NuScale Power, LLC Response to NRC Request for Additional Information No. 410 (eRAI No. 9310) on the NuScale Design Certification Application

## Response to Request for Additional Information Docket No. 52-048

**eRAI No.:** 9310

**NRC Question No.:** 03.09.02-62

Figure 3.9-4: Core Support Assembly

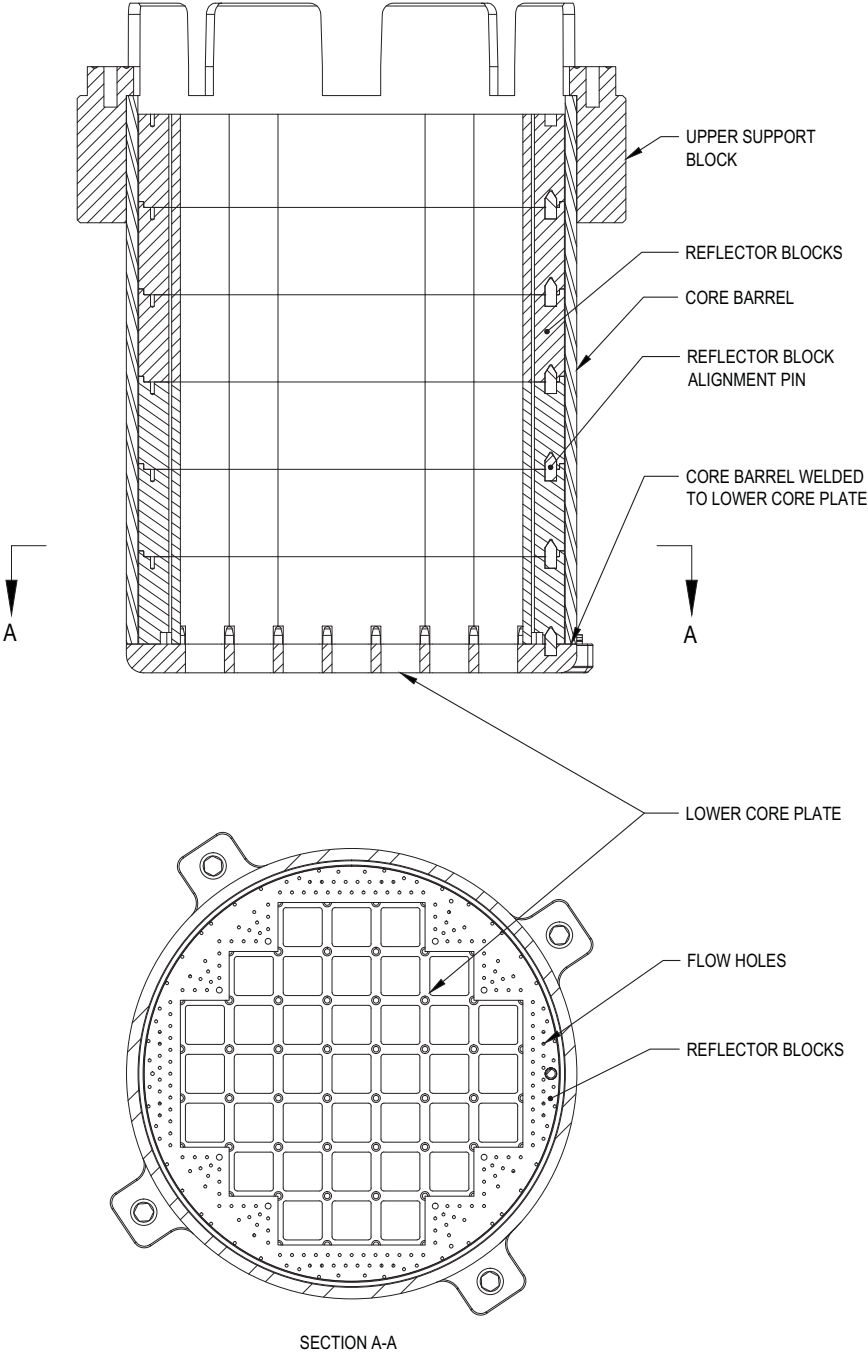
In the response to Subquestion 2 and 3 of RAI 8911, Question 03.09.02-27, the applicant stated that Belleville washers are placed below the lower core plate to tune the core's vertical natural frequency away from high vertical NPM acceleration frequencies that has peak near 17 Hz. A target core vertical frequency of 6 Hz was selected. To achieve the target frequency, the combined spring constant of the 10 Belleville washers acting in series at each core support block was calculated to be 106,800 lbf/in. However, EC-A010-2322-R2, "Reactor Module Seismic Model" Section 2.1.5 stated that four Belleville washers are assumed to exist at bottom of core support with spring constant of 1.068E5 lbf/in for each of the four washers. The staff is not clear how the combined spring constant of 106,800 lbf/in is obtained for the 10 Belleville washers acting in series. Provide the following information:

1. Spring constant for each of the 10 Belleville washers acting in series and the formula used in calculation of the combined spring constant of 106,800 lbf/in.
2. Clarify that the Design in-structure response spectra (ISRS) of the top and lower core plates (Fig. B16 to Fig. 21 in TR-0916-51502) are calculated from the NPM seismic model with 10 Belleville washers in series, not 4 Belleville washers in series, below the lower core plate.

The Belleville washers in the lower reactor internals have been removed from the NuScale design. Therefore, these questions are no longer applicable. The Belleville washers were removed from the design because an artificial acoustic resonance that significantly increased loads in the reactor vessel internals was isolated. The artificial resonance was caused by an assumption of complete reflection of acoustic waves in the reactor pool at the reactor pool floor, when in reality the energy is partially reflected and partially absorbed. After performing a detailed modeling of the fluid-structure interaction, the artificial resonance was eliminated, and the seismic Belleville washers became no longer necessary.

The core support block attachment configuration for the lower reactor internals is shown in Figure 1. The Belleville washers have been replaced with socket head cap screws and shear pins, that provide a circumferential and vertical restraint. The interfacing slotted holes on the lower core plate permit relative thermal growth of core support and lower RPV. The radial direction restraint is therefore released in the NPM seismic model.

The FSAR Tier 2 Section 3.9.5 and Figure 3.9-4, Section 4.5.2 and Table 4.5-2, and Section 5.2 Table 5.2-7 have been revised as described in the response above and as shown in the markup provided with this response.
